- 1.1 The applicant seeks planning permission from the Town Planning Board (the Board) to use *Various Lots in D.D. 83, Lung Yeuk Tau, Fanling, New Territories (the Site)* for '**Proposed Temporary Public Vehicle Park (Excluding Container Vehicle) for a Period of 3 Years and Associated Filling of Land**' (proposed development) (Plan 1).

(S.16 Planning Application No. A/NE-LYT/806)

Departmental Comments		Applicant's Responses
1. Comments of Commissioner for Transport (Contact Person: Mr. Eric TAM; Tel: 2399 2405)		
(a)	Please provide the data results of the traffic count surveys conducted on 27/09/2023.	A new traffic count survey was conducted on 17 October 2023 (Tuesday) over the AM and PM peak periods between 07:00 to 10:00 and 16:00 to 19:00 respectively. The AM and PM peak hour is identified to occur at 07:30 - 08:30 and 16:00 - 17:00 respectively. Figure 1 presents the data results in PCU of observed existing weekday AM and PM peak hour traffic flows on the road network in the vicinity of the project development.

Date19/10/2023 ScaleN.T.S		Project Title Proposed Temporary Public Vehicle Park for a Period of 3 Years in DD 83, Ma Liu Shui San Tsuen, Fanling	OZZO TECHNOLOGY
			Project No. 82854 Dwg No. Figure 1 Rev. -

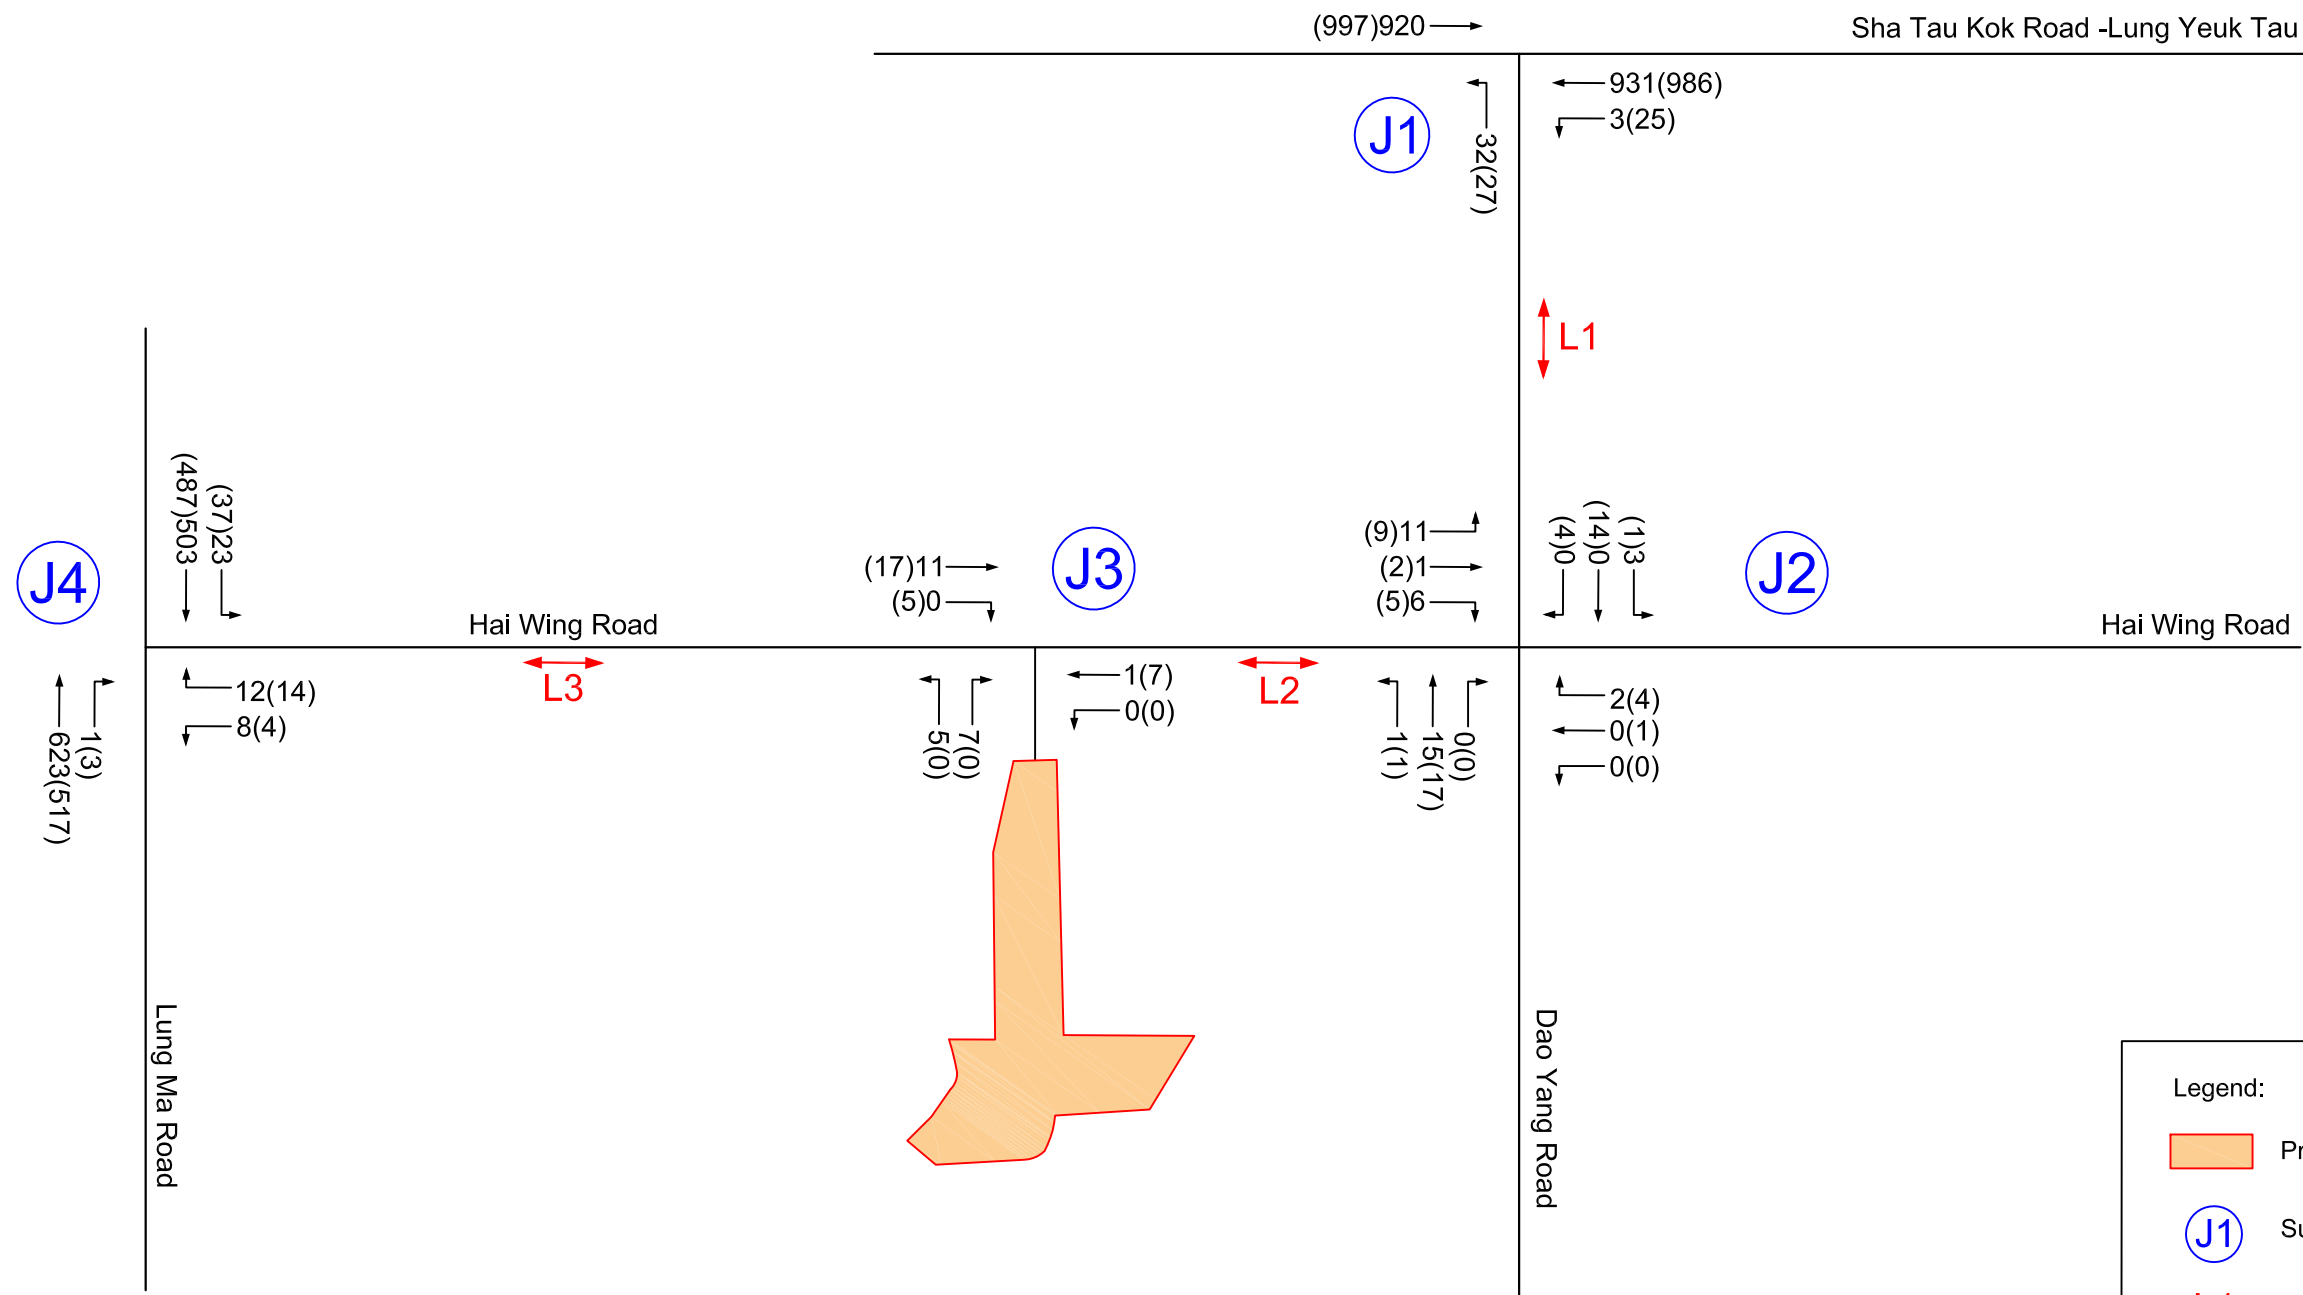
(b)	Please include a volume capacity analysis in the assessment on the existing performance of the road network.	Volume capacity analysis of the existing performance is assessed and is shown in the following table. Locations of assessed junctions and links location can refer to Figure 1. Existing Peak Hour Junction Capacity Assessment

Project No. 82854	Rev.
Dwg No. Figure 2	-

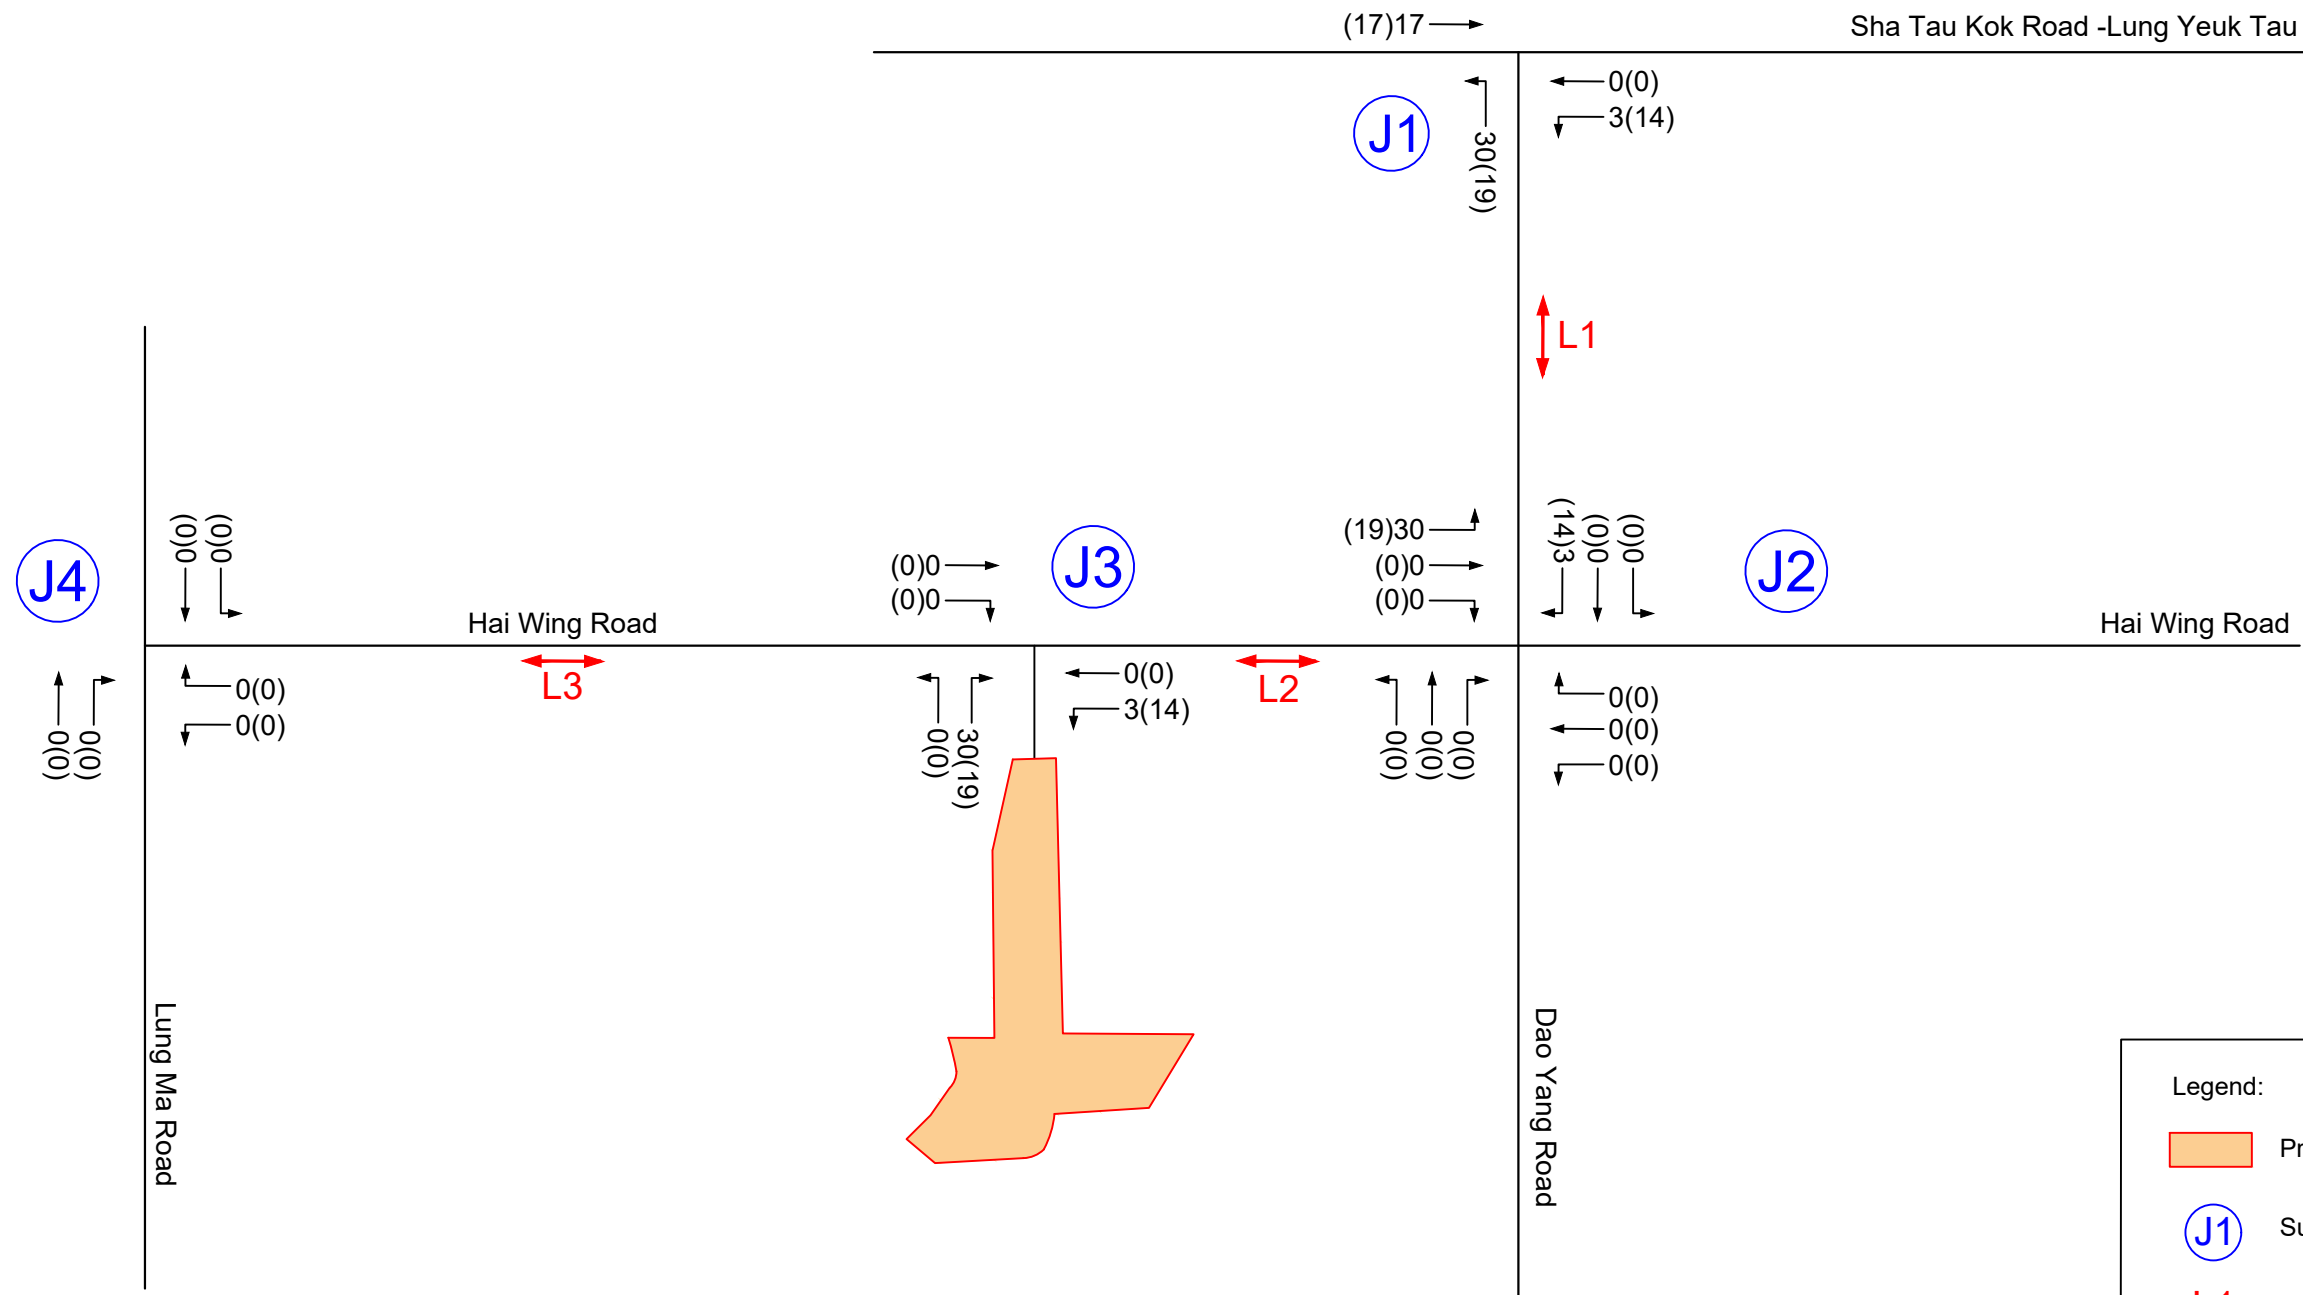
Please clarify if the table presented in Annex I of 1st FI has included the cumulative assessment on existing condition and the estimated traffic generation and attraction rates by the proposed development.

The Site is the subject of a previous approved application No. A/NE-LYT/775. Based on the approved scheme of A/NE-LYT/775, a total of 24 parking spaces are provided, the existing peak hour trips to be generated / attracted are 1 and 11 (AM peak); and 5 and 7 (PM peak) respectively. For the current application No. A/NE-LYT/806, with 64 spaces are provided, the estimated trips are is projected to be 33 trips in the AM peak (in 3, out 30) and 33 trips in the PM peak (in 14, out 19) respectively. The development flow trips are shown in **Figure 2**.
